Attachment 3

Revision to the TS Bases Markups for

TS 3.2.1B and TS 3.2.1C

Technical Specification Bases 3.2.1B
Heat Flux Hot Channel Factor Markups

Figure B 3.2.1B-1 (page 1 of 1)
 $K(Z)$ - Normalized $F_0(Z)$ as a Function of Core Height

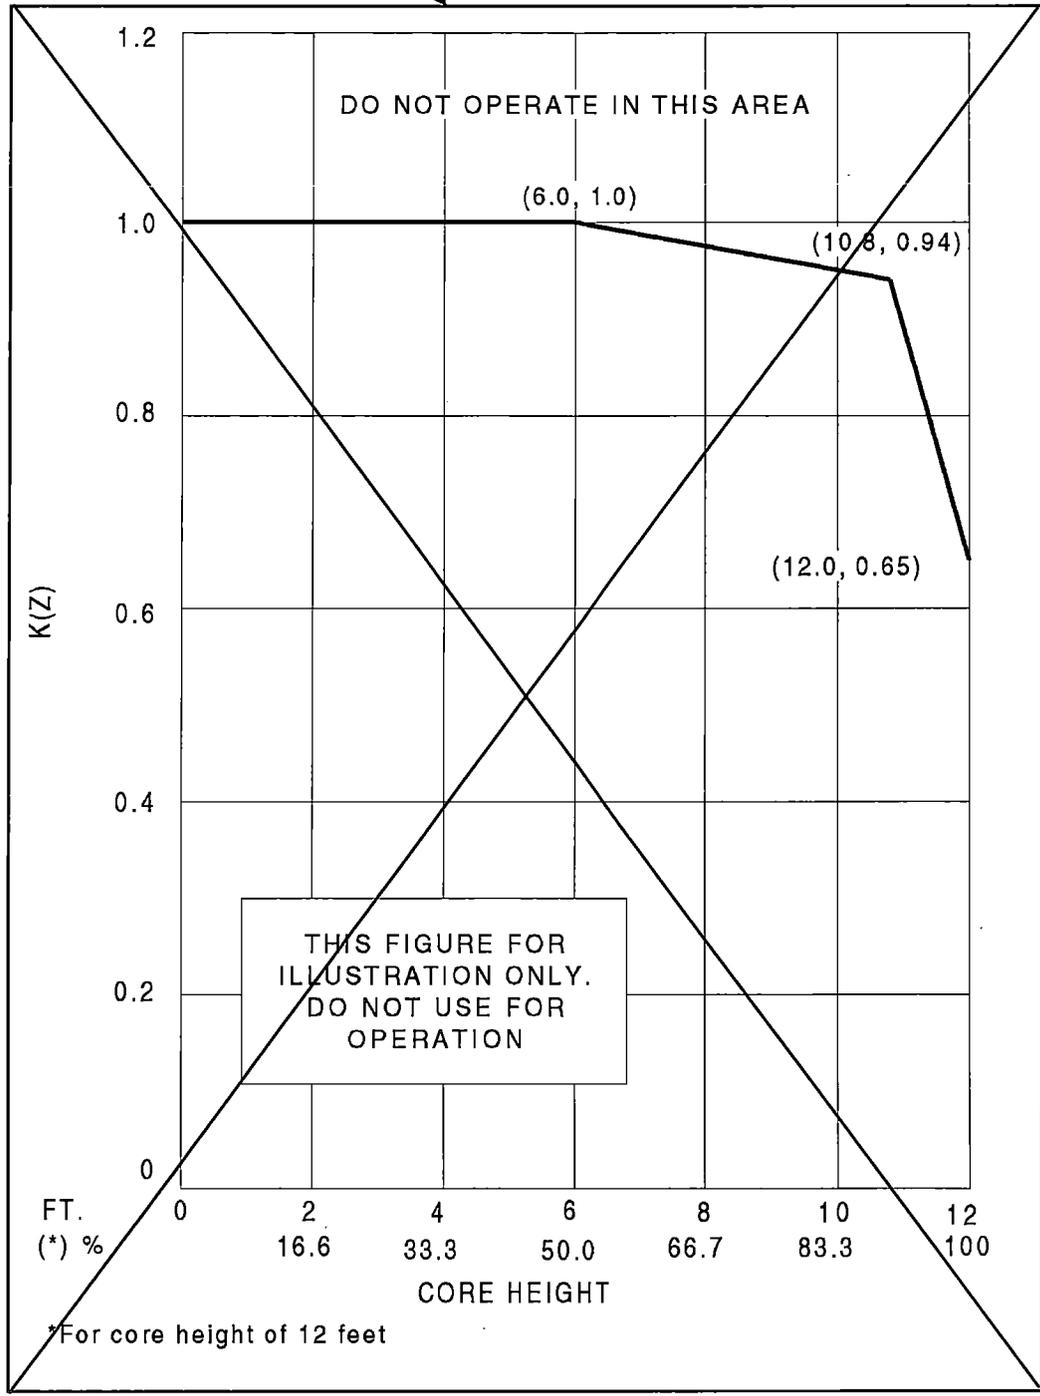
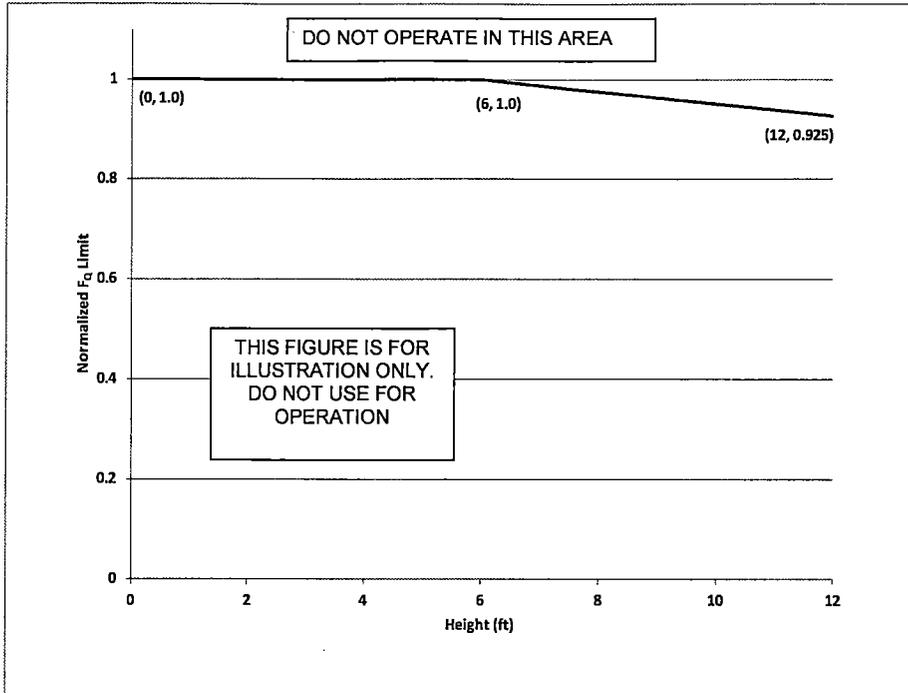
For this facility, the actual values of CFQ and $K(Z)$ are given in the COLR; however, CFQ is normally a number on the order of [2.32], and $K(Z)$ is a function that looks like the one provided in Figure B 3.2.1B-1.

Insert new Figure (Next Page)

Figure B 3.2.1C-1 (page 1 of 1)
 K(Z) - Normalized F_a(Z) as a Function of Core Height

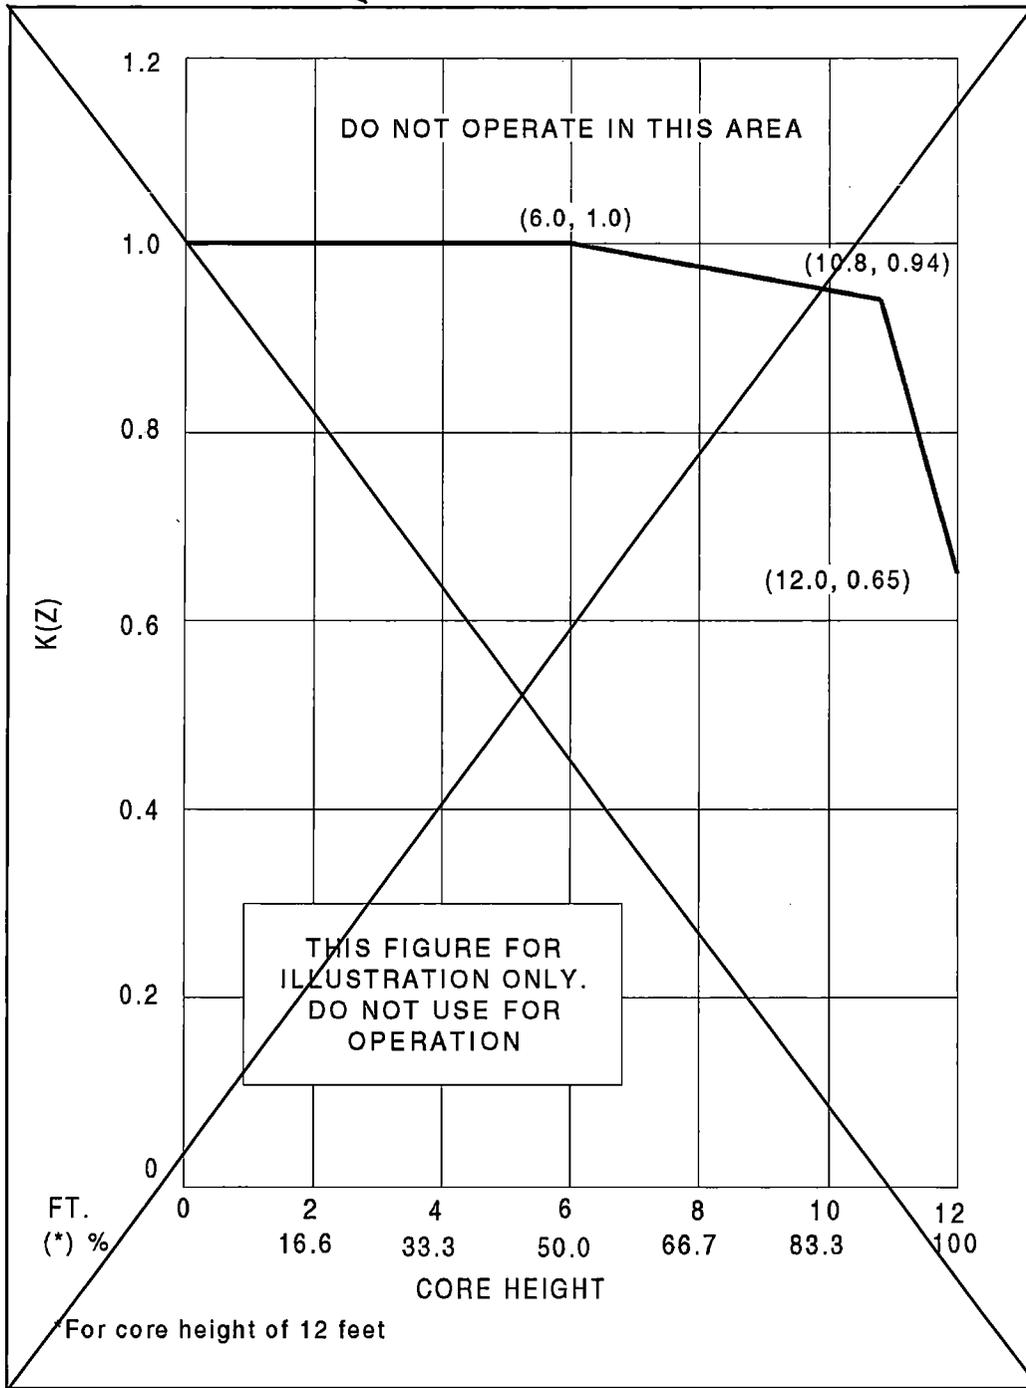
For this facility, the actual values of CFQ and K(Z) are given in the COLR; however, CFQ is normally a number on the order of [2.32], and K(Z) is a function that looks like the one provided in Figure B 3.2.1C-1.

Insert new Figure
 (Next Page)
